FINAL PLAT

KISER WEST ADDITION

RE: SUB 2001-74 -- One-Step Final Plat of Kiser West Addition

STAFF REPORT

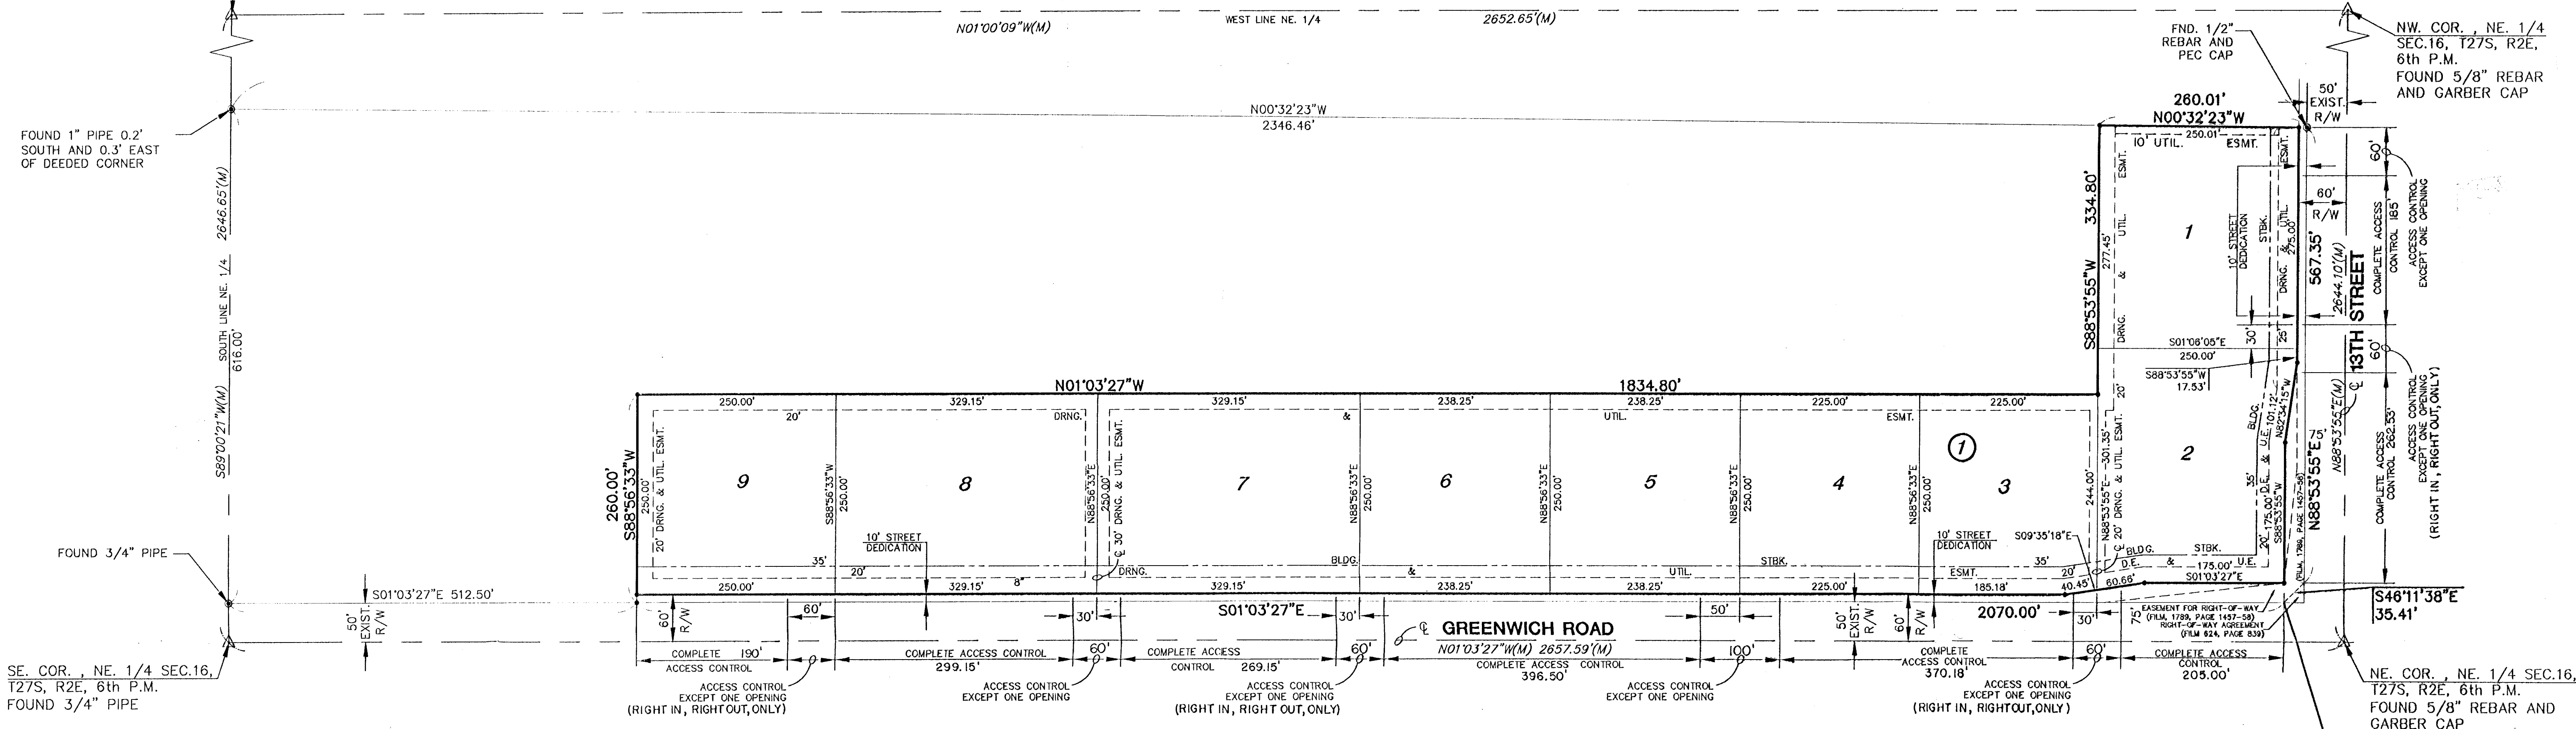
- E. The plat proposes five access openings along Greenwich and two access openings along 13th St. Distances should be shown for all segments of access control. In accordance with the CUP approval, the access openings located between lots 1 and 2, 2 and 3, and between lots 6 and 7 are limited to right-turns only, and shall be referenced on the face of the plat.

- I. A note shall be placed on the final plat, indicating that this Addition is subject to the conditions of the Kiser West Community Unit Plan (CUP 2000-21, DP-254).

- J. On the final plat, the MAPC signature block needs to reference "J.D. Michaelis, Acting Chair".
- K. The applicant needs to revise the legal description to accurately portray the land being platted. If the platted description is different than the legal, then both descriptions shall be shown.

- L. On the north line of Lot 2, the extra "35 feet" label may be removed.
- M. The spelling of the label at the center of the section should be corrected to "Center".

- N. A dimension needs to be added on the south line of the 25-ft drainage and utility easement on the north side of Lot 1.
- O. The labeling of dimensions and dedications along 13th Street and within Lots 1 and 2 needs to be reoriented 180 degrees to be aligned with the north arrow.
